### DEPARTMENT OF THE ARMY NATIONWIDE PERMIT AUTHORIZATION

This is in reply to your request, dated June 14, 2011 (Enclosure 1), to reverify your Nationwide Permit (NWP) 12 authorization for Single and Complete Project Number (No.) 22 (File No. SPL-2007-00704-SAS). Your original NWP verification letter, dated January 7, 2011, authorized the discharge fill material into waters of the United States (U.S.) in association with the San Diego Gas & Electric Company's (SDG&E) proposal to construct the Sunrise Powerlink Project (Sunrise Powerlink), a power transmission line along an approximately 120-mile alignment from the Imperial Valley Substation in Imperial County, California to the Sycamore Canyon Substation in the County of San Diego, California (Enclosure 1) and is incorporated here by reference.

**SUNRISE POWERLINK:  
NOTIFICATION AND/OR REQUEST FOR CHANGE IN CONSTRUCTION ACTIVITY  
“WATERS OF THE US” AND “WATERS OF THE STATE”**

Corps of Engineers File Number: SPL-2007-00704-SAS  
State Water Resources Control Board File Number: SB09015IN  
Department of Fish and Game Notification Number: 1600-2009-0365-R5

**EXHIBIT 1: Mapsheet 12**

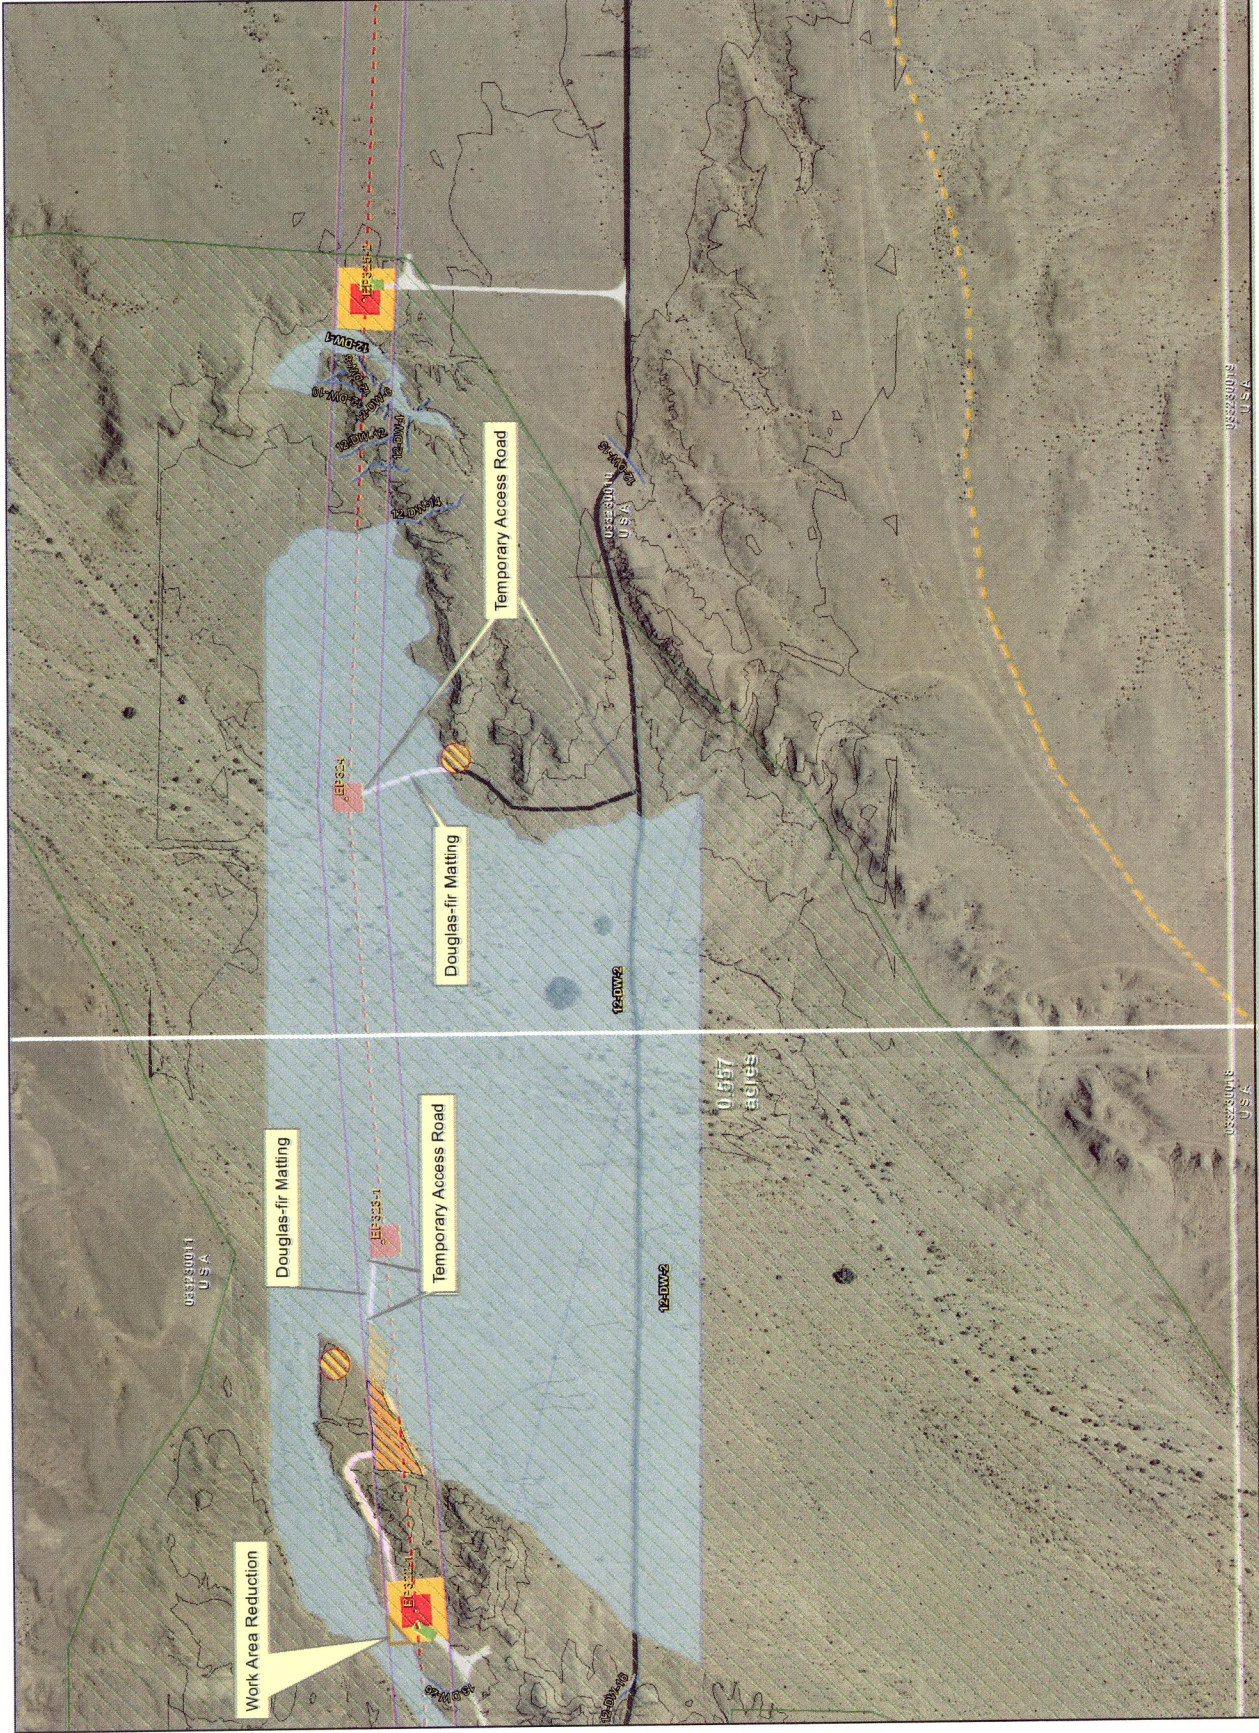
<p>To safely set down the mats and have them remain securely in place, a minimum width of 12 feet of relatively flat ground is required. Where present, vegetation would be cleared or crushed. On the access road to EP323-1, uneven terrain would be smoothed using a skid steer. Where mats are used on the access road to EP324, uneven terrain would be smoothed by hand grading crews. During smoothing operations on both access roads, fiber rolls would be placed as needed on the downslope side to protect the dry wash from displaced soils. Once the mats are in place, the fiber rolls would be removed. It is estimated that the Douglas-fir mats would remain in place on both roads for approximately 4 months.</p> <p>After construction at EP323-1 and EP324 is complete, the Douglas-fir mats would be removed and the entire length of both temporary roads will be restored to pre-construction conditions. Maintenance of both structures would occur by helicopter as originally planned.</p>

<p><b>Reason for Change</b></p>	<p>The change to the temporary work area at EP322-1 is proposed to partially offset the increase in temporary impacts to 12-DW-2 from the addition of temporary access roads to EP323-1 and EP324.</p> <p>The change in foundation type at EP323-1 and EP324 is proposed because:</p> <ol style="list-style-type: none"> <li>1. There is a high potential for scouring at both sites because of their location within a dry wash;</li> <li>2. Upgrading the micropile foundations to handle the scouring would substantially increase the duration of construction activities and the amount of materials required at each site; and</li> <li>3. Traditional foundations have less potential than micropiles to be affected by scouring.</li> </ol> <p>The change in construction method is proposed because construction of traditional foundations requires different and more equipment than required for micropiles. The temporary access roads are needed to transport equipment to the site and are part of the change in construction method.</p>

<p><b>Effect on Waters of US and/or Waters of the State</b></p>	<p>The reduction in the size of the EP322-1 work area and the addition of access roads to EP323-1 and EP324 will result in a net increase of 0.10 ac of temporary impacts to Waters of the US and Waters of the State in 12-DW-2. The change increases total Project temporary impacts to all dry washes from 6.53 acres to 6.63 acres. The change does not increase or decrease permanent impacts to 12-DW-2; the Project's total permanent impacts to all dry washes would remain the same.</p> <p><b>EP322-1 Temporary Work Area Reduction:</b>  Original Area = 0.92 AC (40,000 SF)  Area in Dry Wash = 0.08 AC (3,455 SF)  New Reduced Area = 0.84 AC (36,545 SF)</p> <p><b>EP323-1 Temporary Road Impacts Increased:</b>  Area in Dry Wash (Matting) = 0.08 AC (3,324 SF)  Total Road Area = 0.08 AC (3,324 SF)  Total Length of Road = 210 LF</p> <p><b>EP324-1 Temporary Road Impacts Increased:</b>  Area in Dry Wash (Matting) = 0.10 AC (4,432 SF)  Total Road Area = 0.36 AC (15,874 SF)  Length of Road (Matting) = 280 LF</p>

1. Modify the construction of and temporary access to structures EP322-1, EP323-1, and EP324, as detailed in Enclosure 2, resulting in a 0.1-acre increase in temporary impacts to waters of the U.S. within 12-DW-2. All permanent impacts associated the construction of with EP322-1, EP323-1, and EP324 shall remain the same as authorized on January 7, 2011.
